# UNITED STATES PATENT AND TRADEMARK OFFICE

APPLICATION NO.	FILING DATE	FIRST NAMED INVENTOR	ATTORNEY DOCKET NO.	CONFIRMATION NO.
10/689,929	10/17/2003	Chih-Ching Hsien	PUSA030929	4878

<b>Office Action Summary</b>	<b>Application No.</b> 10/689,929	<b>Applicant(s)</b> HSIEN, CHIH-CHING	
	<b>Examiner</b> Hadi Shakeri	<b>Art Unit</b> 3723

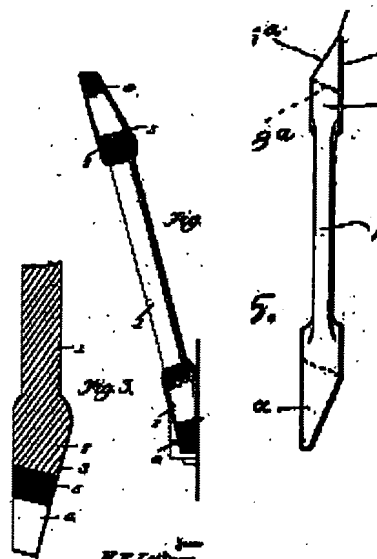
Regarding claims 2, 4 and 5, Jackson in view of either Leitner or Schlehr, meets the limitations as recited, however, it is noted that specific arrangement of element, e.g., starting point of the inclined surface for the different embodiment disclosed (even though teaching references together disclose both), would be further modification well within the knowledge of one of ordinary skill in the art with respect to workpiece and/or operational parameters.

Regarding claim 3, Jackson in view of either Leitner or Schlehr, meets all of the limitations except for the disclosed range for the angle, however, further modifying the tool of

prior art with respect to specific angle, e.g., 15 degrees, would be within the knowledge of one of ordinary skill in the art with respect to workpiece and/or operational parameters.
